801 Dexter

DESIGN REVIEW BOARD

DPD MUP PROJECT NO. 3012351 March 7, 2012

A-5 Respect for adjacent sites

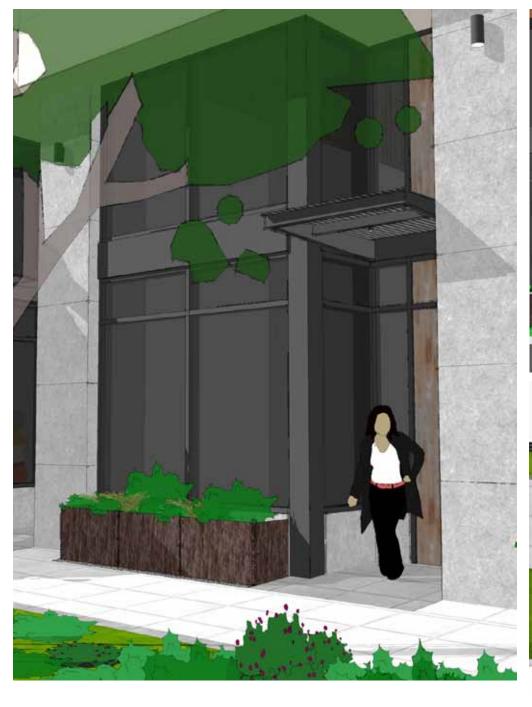
DISCUSSION AT INTERIM EDG: The design was noted as showing roof articulation at Valley and Aloha that follows the grade and reinforces the rhythm of the building articulation.

RESPONSE: Articulation has been further developed at side streets. All outdoor roof terraces and active areas will be oriented away from adjacent buildings.

C-2 Architectural Concept and Consistency

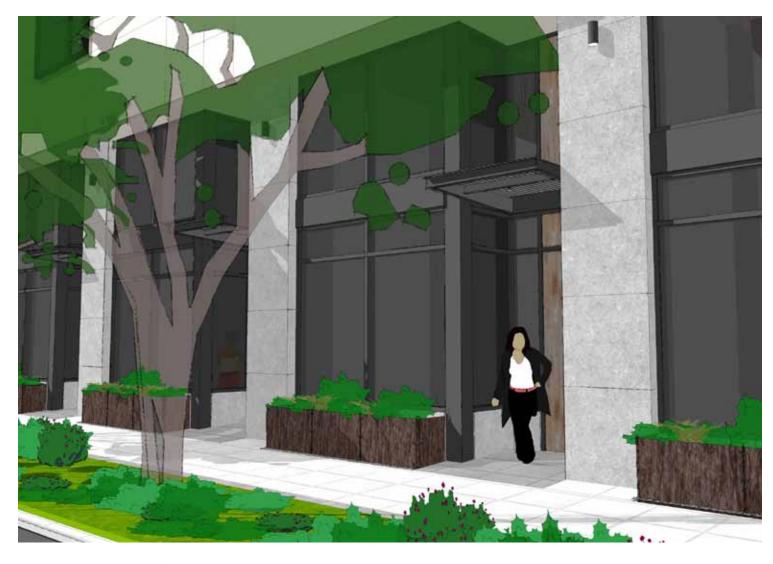
DISCUSSION AT INTERIM EDG: The design showed a taller 2/4 base to enhance the retail presence as previously recommended. The board commented that the building continued the rhythm of 901 (to the north) nicely.

RESPONSE: The building has been developed into a series of smaller well proportioned pieces that respond to the site's sloped character as well as reinforce rhythms found in adjacent developments. The various pieces contribute to a "hill town" concept that will be recognizable from surrounding on site views. A vibrant color palette will also help articulate and emphasize the "hill town" concept. The roofscape has been considered as integral to the design concept with emphasis on elements such as the "butterfly" clerestory element at the club room amenity space, roof terraces, and dog park elevator tower.
